TECHNICAL MEMORANDUM

**Re: Treatability/Pilot Study Modification No. 5
Nevada Environmental Response Trust Site
Henderson, Nevada
Ramboll Project No. 1690006943-032**

This Technical Memorandum presents Ramboll’s recommended modification to the scope of work for the Galleria Drive¹ ZVI-Enhanced Bioremediation Treatability Study Phase I activities currently in progress at the Nevada Environmental Response Trust Site (the “Site”) located in Henderson, Nevada. As presented in the approved Galleria Drive ZVI Bioremediation Treatability Study Work Plan (Work Plan) dated September 29, 2017, a treatability study will be performed to evaluate the feasibility and effectiveness of implementing ZVI-enhanced bioremediation to reduce the contaminant mass flux at the mid-plume containment and mass removal boundary, which has been established as a Remedial Action Objective (RAO) for Operable Unit 2. The location of this treatability study is shown in Figure 1. A geologic cross-section is presented in Figure 2.

Figure
1

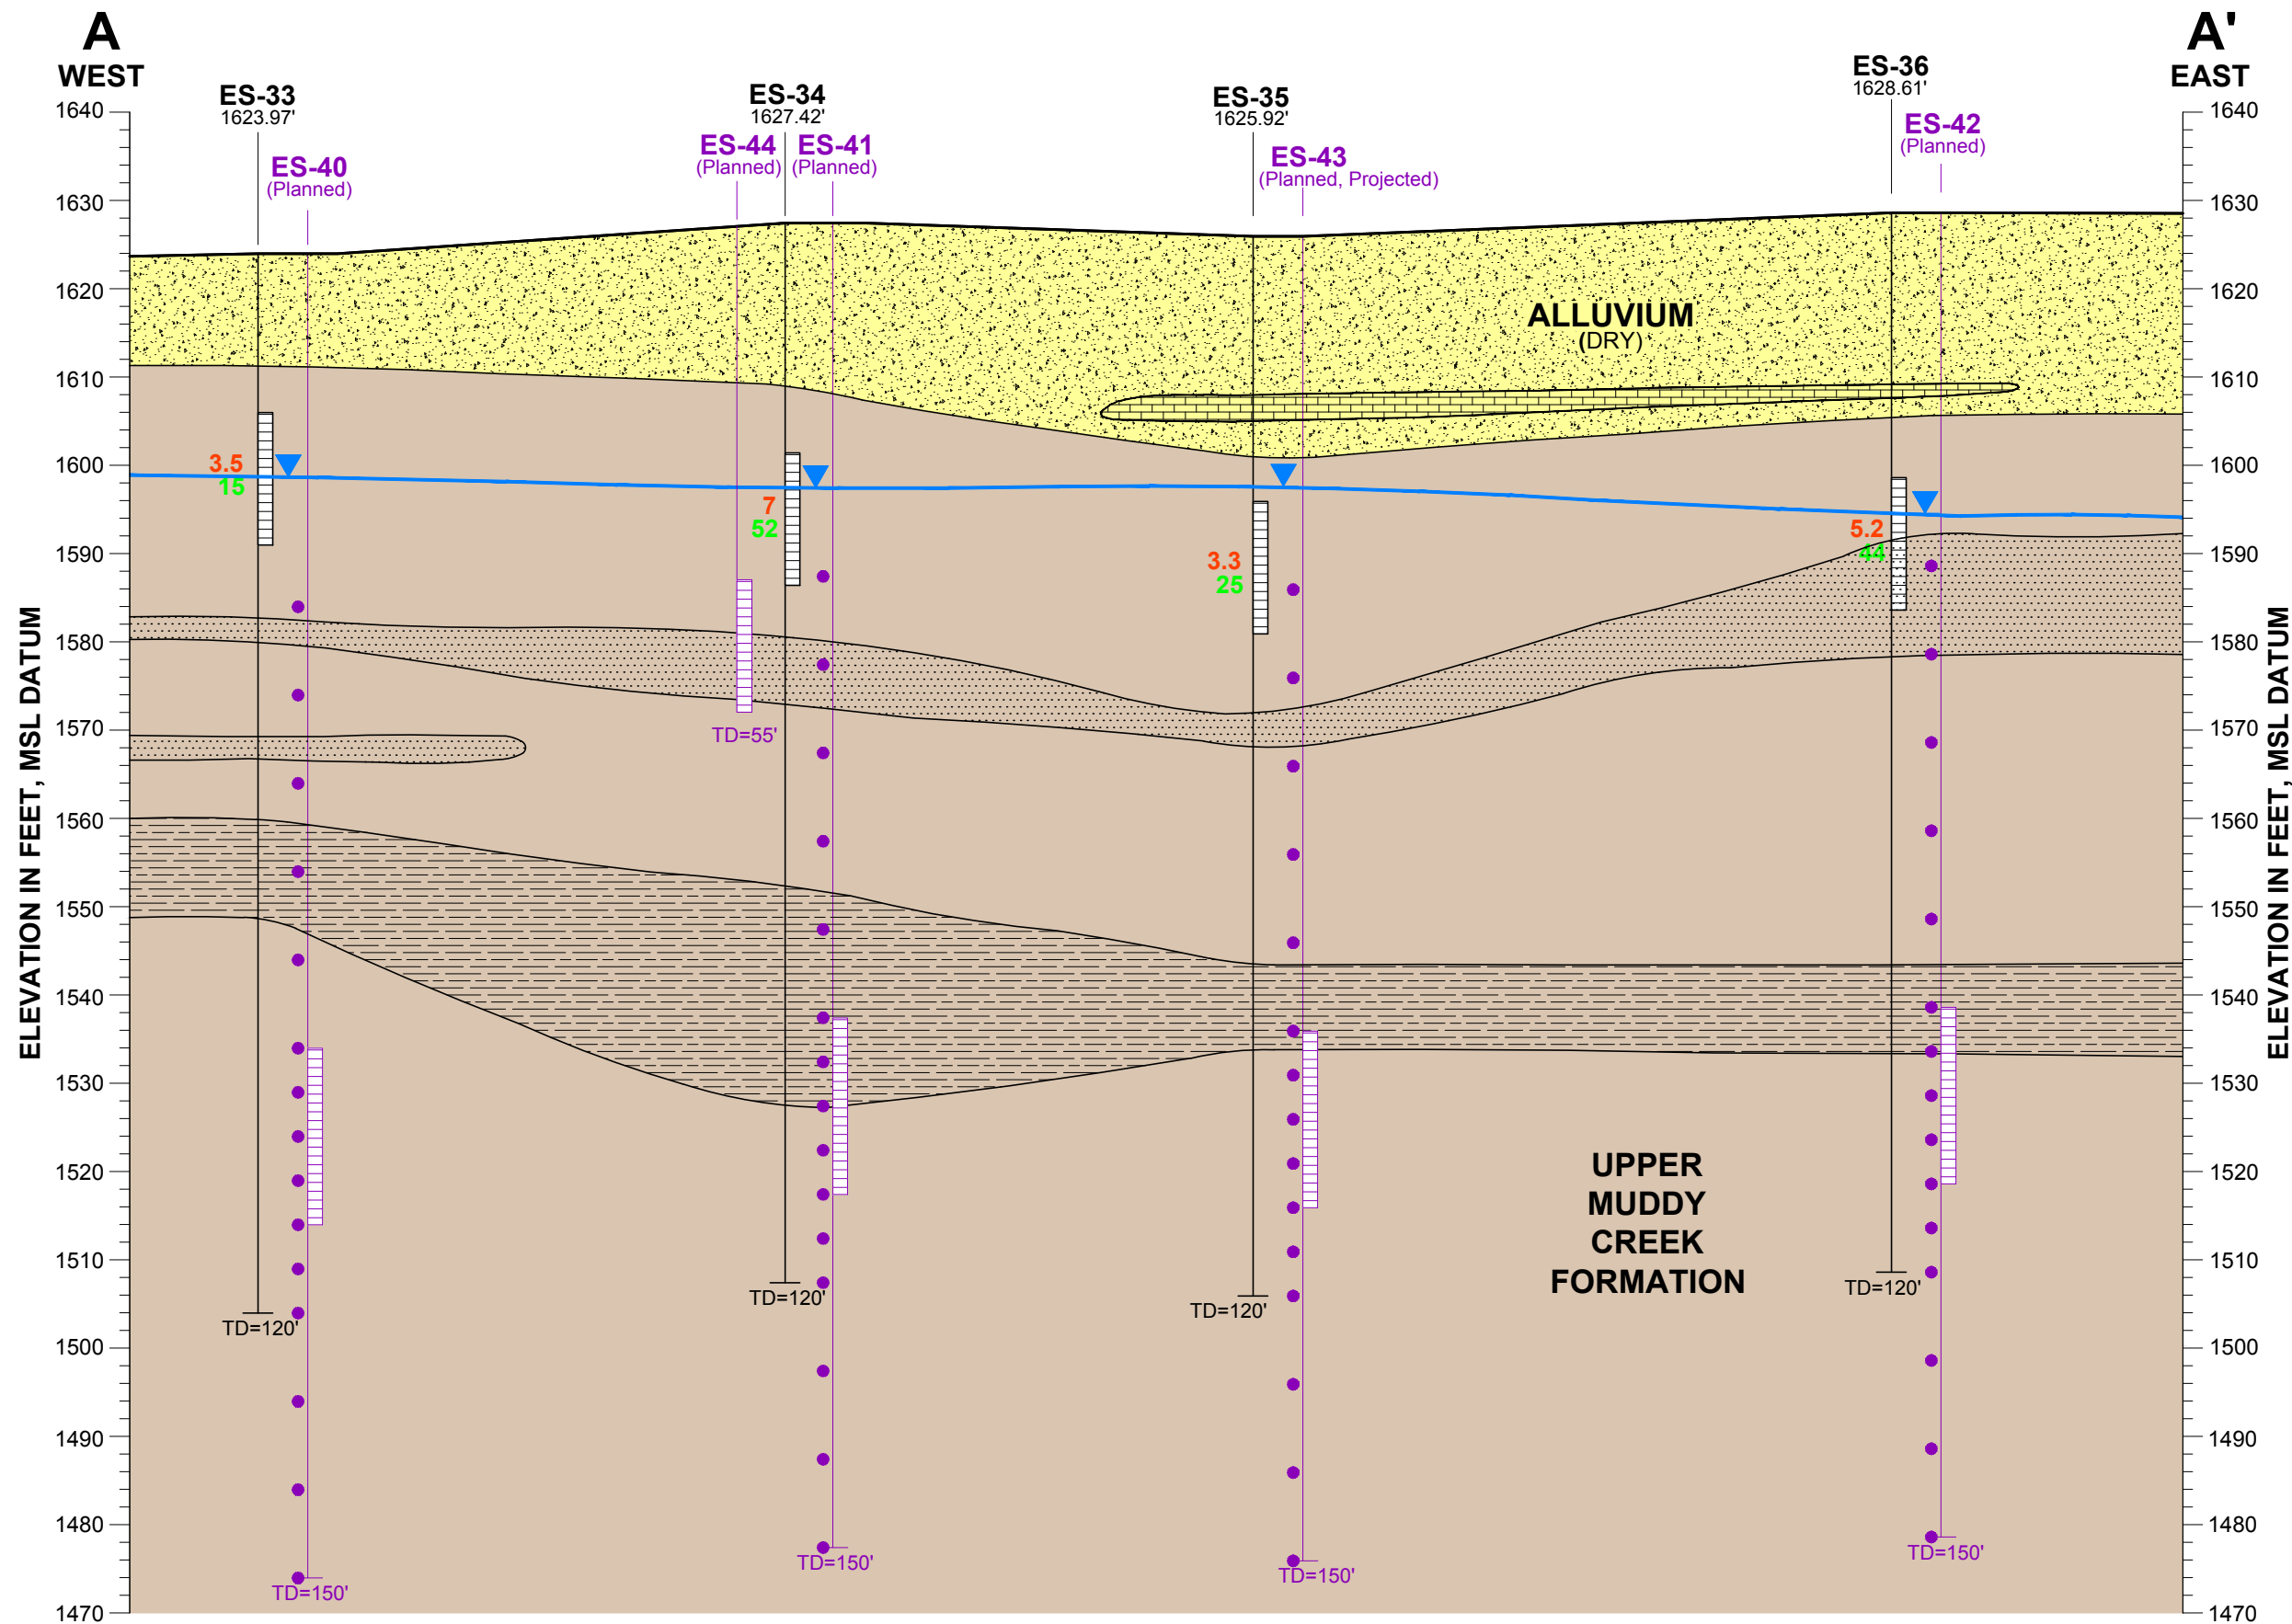
This recommended modification proposes the installation of four deeper monitoring wells and one additional shallow monitoring well with corresponding soil sampling, water sampling, and aquifer testing. All monitoring wells will be installed at the ZVI treatability study area along Galleria Drive. The deeper monitoring wells will be installed to further investigate perchlorate contamination in the deeper Upper Muddy Creek Formation (UMCf) that was encountered during the field investigation activities performed by Tetra Tech as part of their Galleria Drive treatability study located northeast of the ZVI treatability study area. The shallow monitoring well will be installed to target a coarser-grained deposit within the UMCf to better understand the hydrogeological significance of this unit. The results obtained from the additional data collection effort described herein will be used to design the Phase 2 field scale treatability study and will be summarized within the forthcoming addendum to the Work Plan (Work Plan Addendum).

New monitoring wells ES-40, ES-41, ES-42, ES-43, and ES-44. As shown on Figures 1 and 2, five additional monitoring wells will be installed in the UMCf adjacent to existing wells ES-33, ES-34, ES-36, and ES-38, respectively. The borings for ES-40 to ES-43 will be advanced to a planned total depth of 150 feet bgs. These planned wells are anticipated to be screened from approximately 90-110 feet bgs to better understand the nature and extent of perchlorate contamination in the deeper UMCf; actual screen intervals may differ based on evaluation of lithology at the time of drilling. Soil sampling will take place during the installation of each well. Soil sampling will begin at 40 feet bgs with samples being collected at approximately 10-foot intervals. Beginning at 90 feet bgs and continuing until 120 feet bgs samples will be collected at approximately 5-foot intervals. Beginning at 120 feet bgs the soil sampling intervals will revert to 10-foot intervals. ES-44 will be advanced to a planned total depth of 55 feet bgs. The anticipated screened interval will be approximately 40-55 feet bgs to better understand the significance of this coarser-grained unit within the UMCf; the actual screened interval may differ based on evaluation of

Schematic Subsurface Cross-Section A - A'
 Treatability/Pilot Study Modification No. 5
 Galleria Drive ZVI-Enhanced Bioremediation Treatability Study
 Nevada Environmental Response Trust Site; Henderson, Nevada

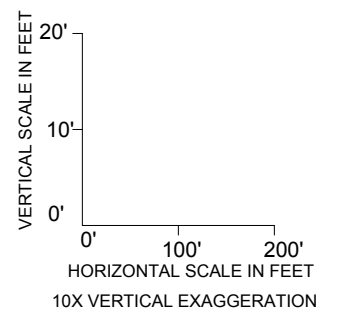
lithology at the time of drilling. One to two soil samples will be collected from the desired zone of interest (approximately 45 to 52 feet bgs).
